From: TM VC
Sent: 23/10/2023 2:11:59 PM
To: Council Northernbeaches Mailbox
Subject: TRIMMED: Objection DA 2023/1289 1112 - 1116 Barrenjoey Road Palm Beach
Attachments: Objection 1112-1116 Barrenjoey Rd Palm Beach Final 231023.docx;

OBJECTION: DA2023/1289 1112-1116 BARRENJOEY RD PALM BEACH 2108
CONSTRUCTION OF SHOP TOP HOUSING

Figure 1 – 8.5metre height plane breach

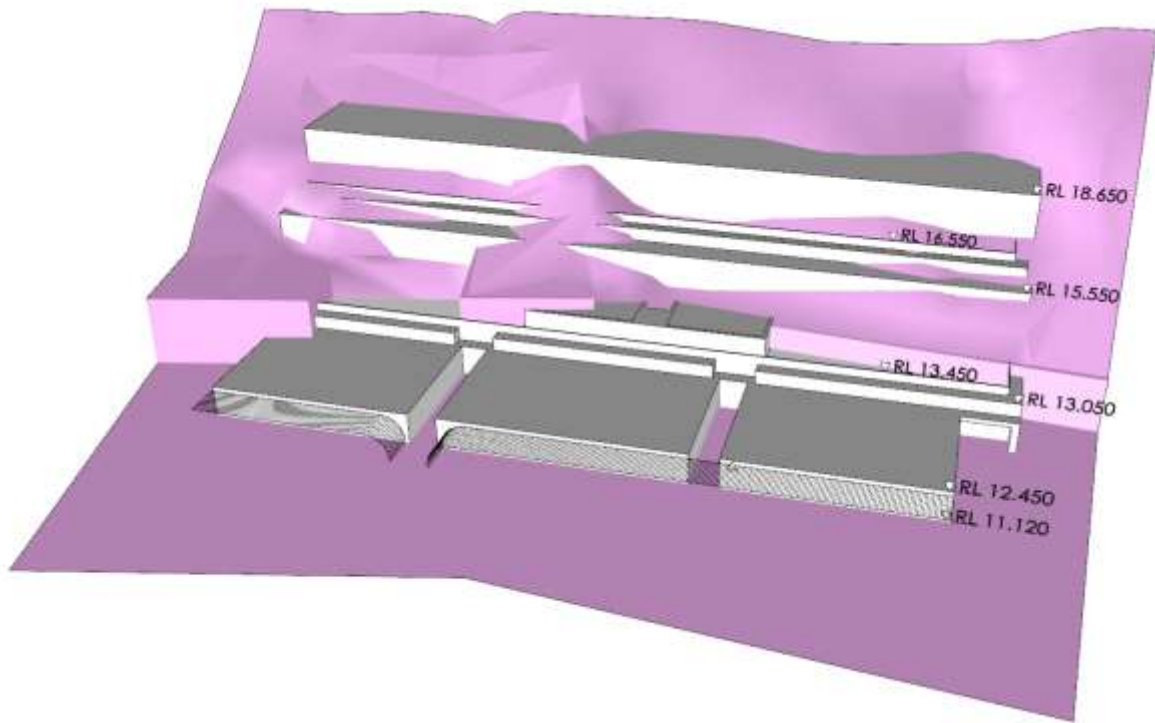
I maintain that the 8.5m height plane as shown on DRG No A0430 diagram 1 does not accurately represent the real extent of the proposed building's breach of the 8.5 metre height limit as adjusted for the flood planning level where applicable.

It appears that the height plane has been established using either the NGL + the flood planning level of RL 3.120 as shown on sections 01, 02 and 03 or some other unknown criteria. However, I have been advised by my architect, my town planner and a Council planning officer that the height plane should be established by using the existing ground levels as shown on the submitted survey plans and further that the requirement of 4.3(2A)(b) of the PLEP should be applied which states that
“(2A) *Despite subclause (2), development on land -*

This would limit the height plane above the flood plane level in the flood effected areas of the site to RL 11.120.

I believe that figure 1 below represents a more accurate image of the proposed building's breach of the 8.5 metre height limit plane.

I further contend that as can be seen in figure 1 on page 3 the breaches over 3 levels of the 8.5 metre height plane are certainly not minor as required under C4.3(2D)(a).

Figure 2 – Proposed excavation (human figures are scaled to 1.8m height)

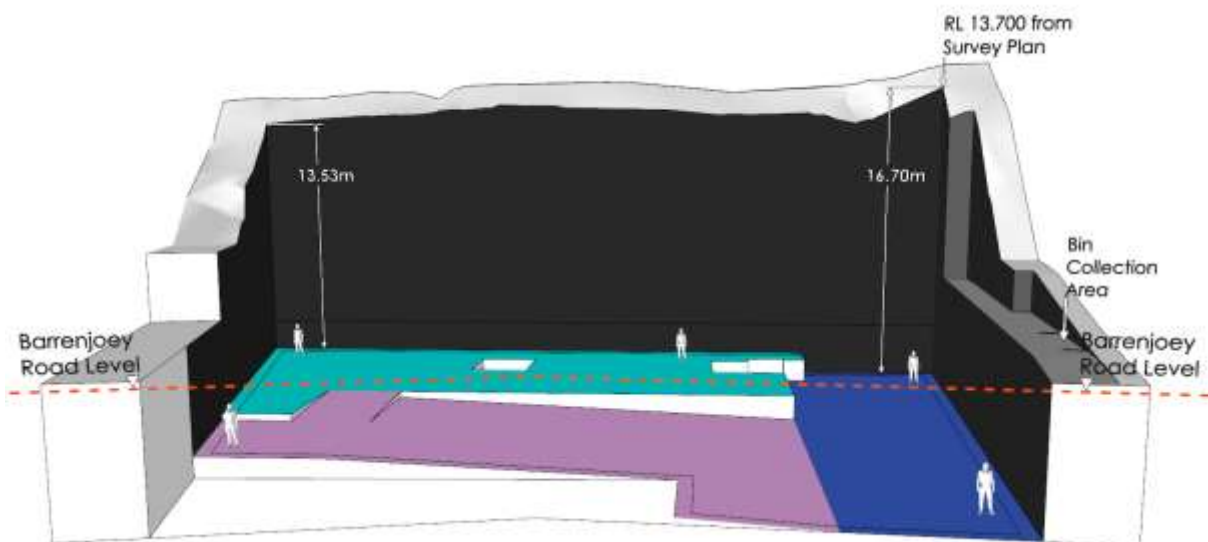
The application requires extensive additional excavation both horizontally and vertically when compared to the currently approved building. The currently approved building has a basement floor level of RL 0.400 while the proposed building would have the entry basement floor level at RL -1.220 (Light blue) and the lower floor level of RL -2.400 (Dark blue) with a 1:20 ramp connecting the two levels (Pink)).

The additional excavation required below RL 0.400 will be approximately 1900 cubic metres. Additionally the Eastern face of the excavation is to be moved further East than what is currently approved by 2.8 meters which will require approximately a further 1270 cubic meters to be removed which would be a total of 3170 cubic meters (more than 6000 tonnes).

This would increase the excavation by at least 70% more than what is currently approved.

My neighbours and I are extremely concerned with the risk this extensive excavation poses to our properties given that the subject site and our properties are in the highest rated slip zone (H1).

Figure 3a. 30% gradient

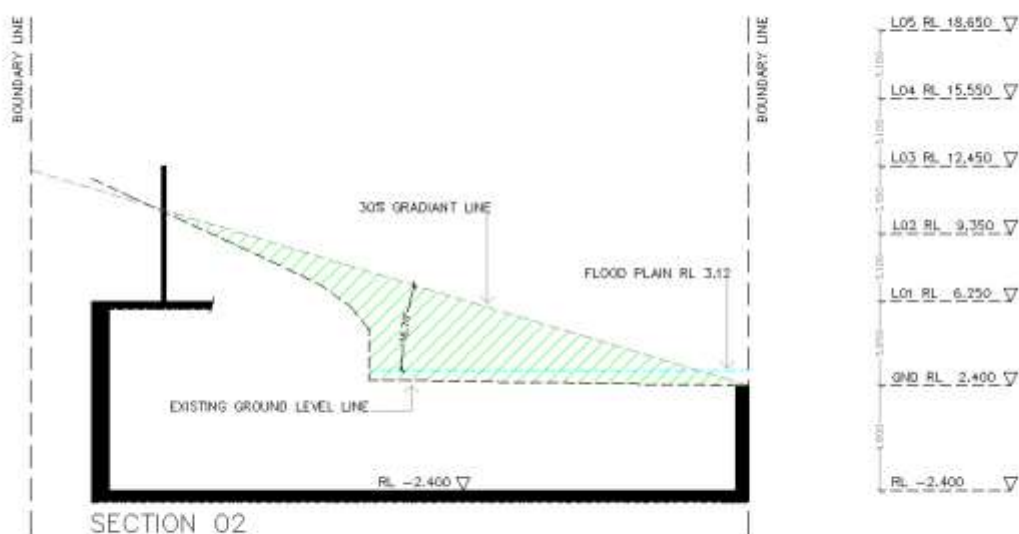
I question that the 30% gradient has been correctly represented on the section drawings 01, 02 and 03 in the Master Set Plans. I understand that the footprint of a building should include the foundations of that building and as such should include the perimeter walls which surround car parking space no's 20, 21, 22 and 23 and the associated columns which support the suspended driveway which provides access from Barrenjoey Road. Consequently, I believe that the 30% slope gradient plane should be repositioned to commence at the western boundary line of sections 01 and 02 as shown in figure 3a and 3b below.

Approximately half of the subject site is flat and, as can be seen from figures 3a, 3b and 3c below, the existing ground level is, except for a small area at the eastern end of Section 3c below and in most areas, substantially below the 30% gradient plane.

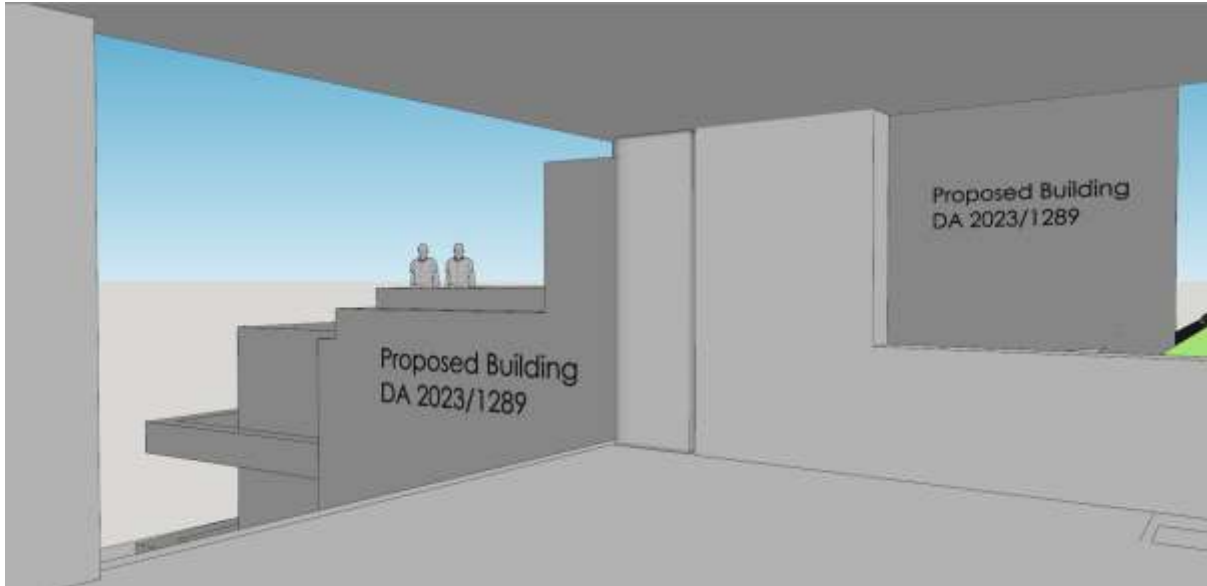
The ADG requires 12 metres of separation between habitable rooms and balconies. The proposed building does not comply with this.

The two storey apartment (apt 301) located on levels 3 and 4 including the balconies seriously impacts the amenity of my main living/lounge area, kitchen and entertaining deck and on my habitable studio on the lower level by way of loss of private water views, loss of privacy, potential noise impact and visual impact.

I maintain that the proposed two storey apartment (apt 301) on level 3 and 4 which breaches the 8.5. height control should be removed completely and the 12 metre separation required by the ADG enforced.
